McCULLOCH CORPORATION

SERVICE BULLETIN

MODEL: All Mini-Mac Chain Saws June 18, 1973

SUBJECT: IMPROVED FUEL HOSE

1

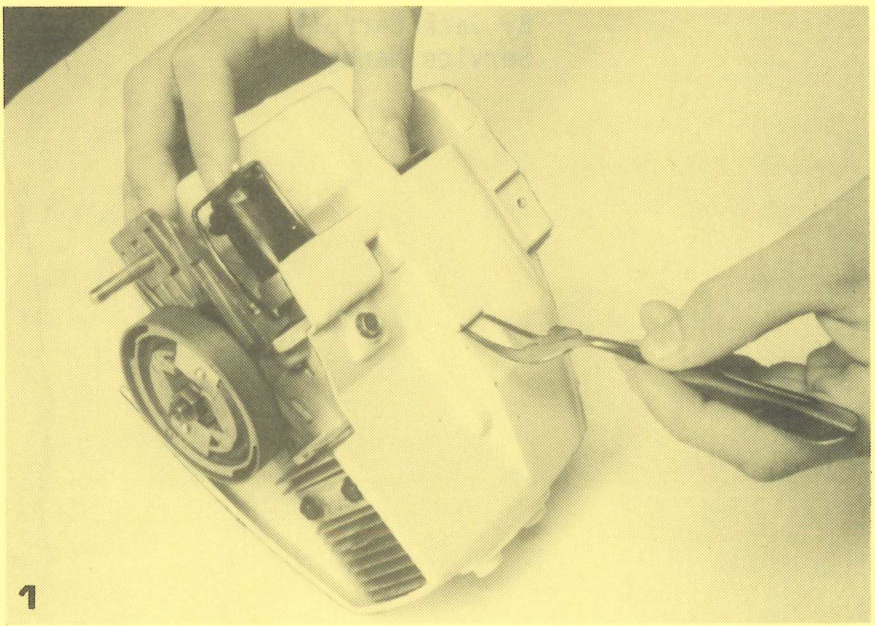
A fuel hose expander tube, P/N 89789, is now being included in Mini-Mac fuel hoses, P/N 83904, for improved sealing and fuel flow.

Installation of the new hose may be aided by using a fork, modified by removing the first and third tines (See Figure 1). To install the fuel/oil tank onto this hose:

1. Grease the lip of the large end of the fuel hose.

2

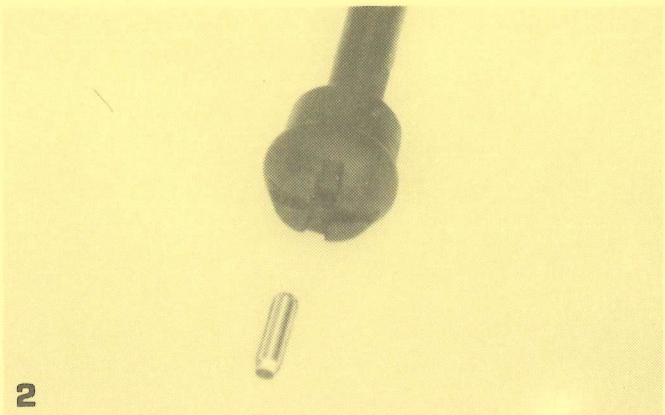
2. Insert the fork into the access hole in the bottom of the fan housing, straddling the fuel hose with the two tines. (NOTE: With earlier fan housing, the access hole must be enlarged with an 1/8 in. chain file.)

3. Install the tank, using the fork to support and straighten the fuel hose as it enters the tank. Inspect the hose through the access hole to make sure it is straight and fully seated.
